L-2010-225  
10 CFR 52.3

October 8, 2010

Re: Florida Power & Light Company  
Proposed Turkey Point Units 6 and 7  
Docket Nos. 52-040 and 52-041  
Response to NRC Request for Additional Information Letter No. 005 (eRAI 4899)  
Standard Review Plan Section 13.06 – Physical Security

Figure 1 – Units 6 & 7 Plant Layout

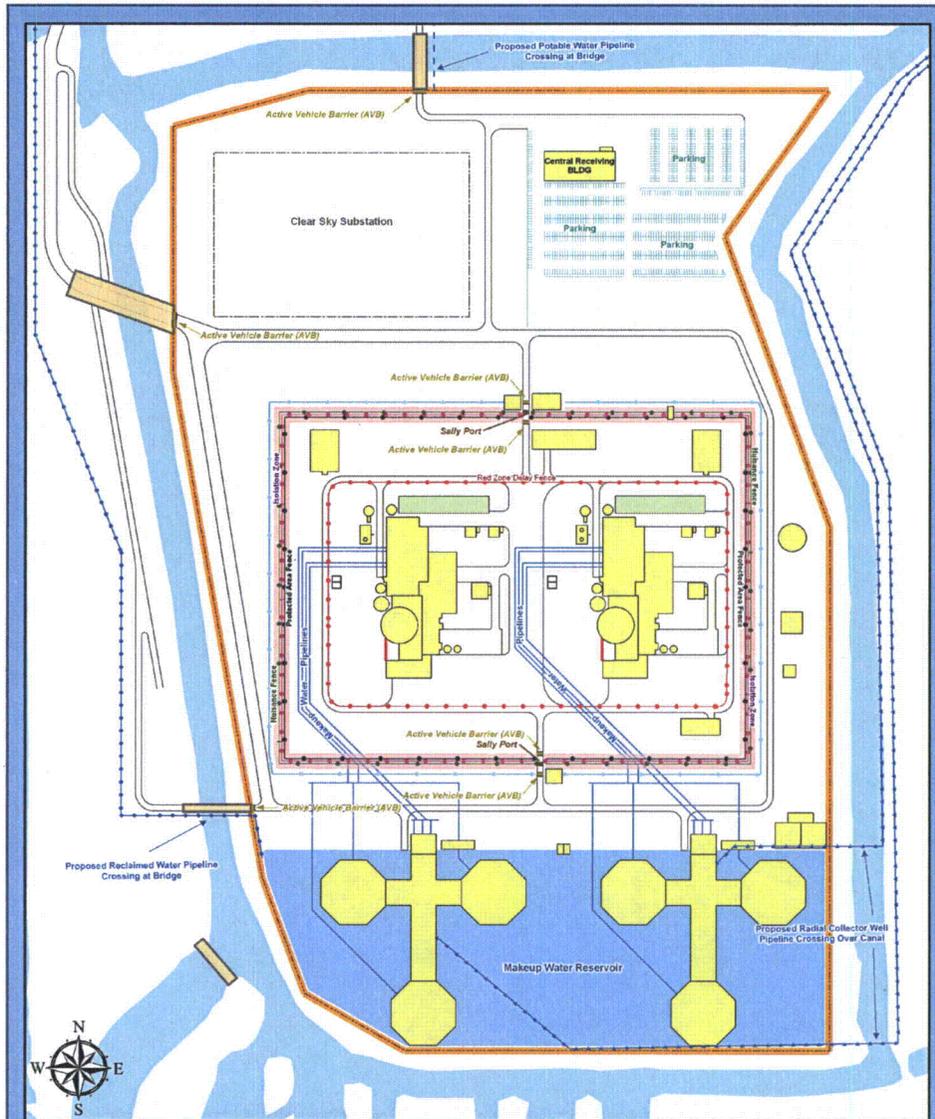
Please provide additional detail with respect to Physical Security Plan, Section 11.1, regarding the location and design of the retaining wall. Please provide additional detail on the location of the wall, grade height on either side of the wall, waterway access to the wall, and tidal effects on the waterway elevation on the wall. Please provide a simple description of the wall (including the information requested above) in section 11.1 of the PSP, and please revise Figure 1 in the PSP to clearly identify the location of the wall.

Backfill will be placed around the perimeter of the Units 6 & 7 plant area and compacted to an approximate elevation of 0 feet NAVD 88 to create a working base for a mechanically stabilized earth (MSE) wall. This wall would be constructed around the perimeter of the Units 6 & 7 plant area, excluding the south side of the plant area where the makeup water reservoir would provide the plant area exterior wall. The MSE wall would extend from its base at approximately 0.0 feet NAVD 88 to a height that would range from elevation 20.0 feet to 21.5 feet NAVD 88. The interior area will be backfilled to the finished grade elevation adjacent to the power block of 25.5 feet NAVD 88. The wall would be designed to retain the interior soil mass while also resisting wave forces resulting from the probable maximum hurricane (PMH).

Figure 1 (below) shows that the MSE wall is surrounded by cooling canals and a small amount of soil between the wall and the canals. These cooling canals support operation of Turkey Point Units 1 through 4. The cooling canals are part of a closed loop system that is completely within the bounds of the owner controlled area. However, there are minor canal water level fluctuations related to tidal influence and the number of existing units in operation. These canal water level fluctuations will have minor effect on the cooling canal level relative to the height of the MSE wall.

Figure 1 will be updated to clearly identify the location of the wall in a future revision of the PSP.

Figure 1 – Units 6 & 7 Plant Layout

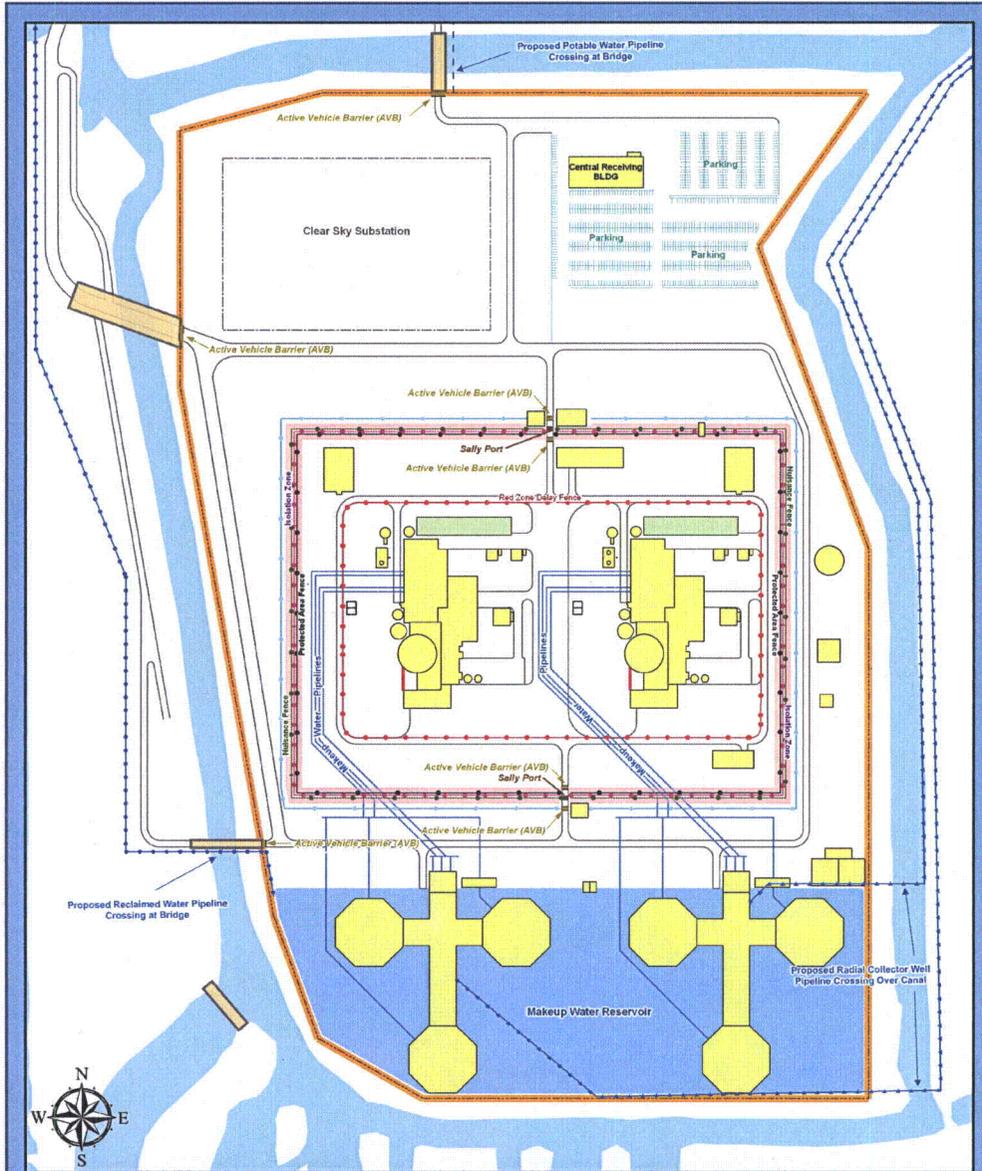
Please provide details in Physical Security Plan, Section 11.1, regarding the design, operation, and use in the physical protection program of the OCA nuisance fences illustrated in figure 1 of the PTN 6&7 PSP.

Figure 1 will be updated to clarify the location of the nuisance fences in a future revision of the PSP.

**Figure 1 – Units 6 & 7 Plant Layout**

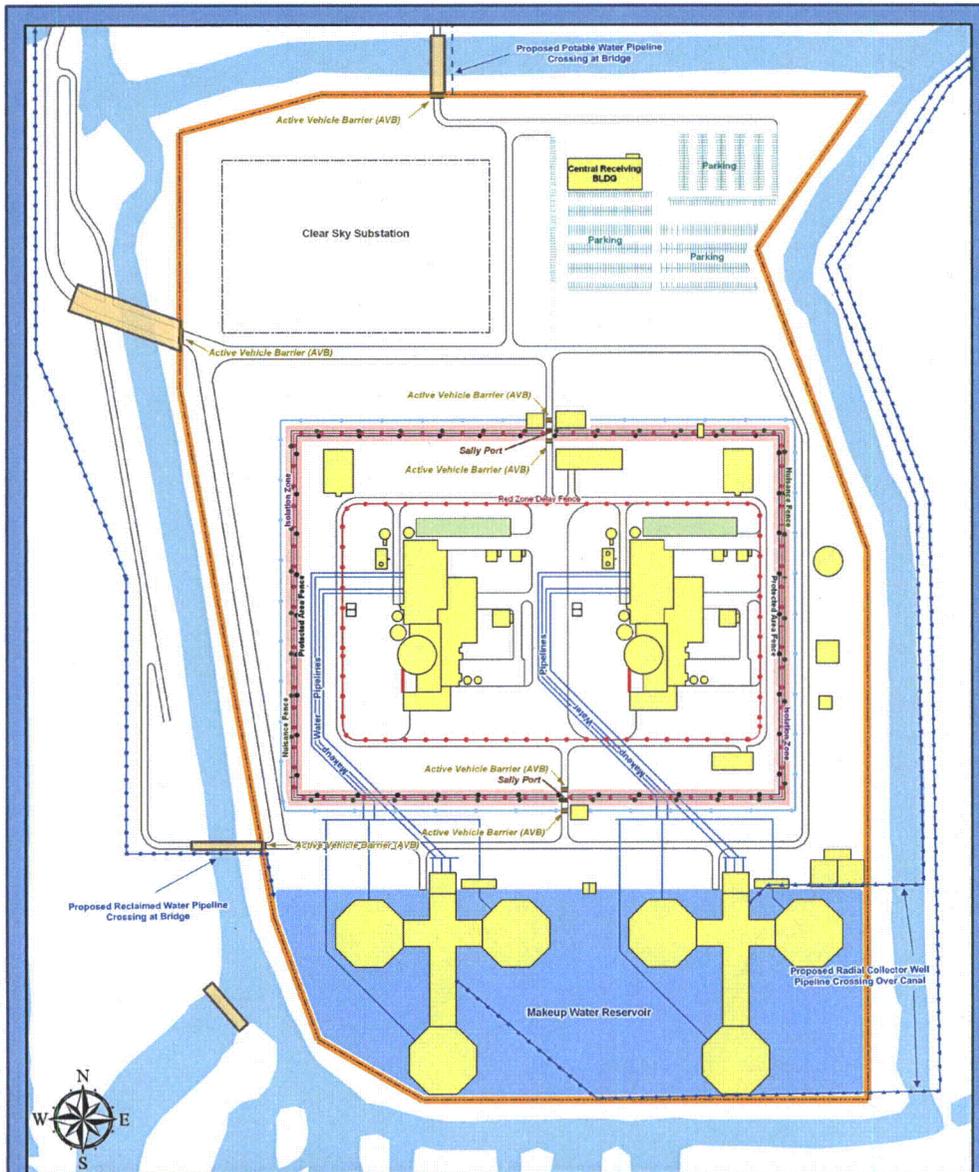
Please provide details in Physical Security Plan, Section 11.1, regarding the design, operation, and use in the physical protection program of the delay fence illustrated in figure 1 (North-West corner of site) of the PTN 6&7 PSP.

The fence in the North-West corner of the site is not a delay fence. It is the fence around the switchyard. Figure 1 will be updated to clarify the location of the delay fences in a future revision of the PSP.
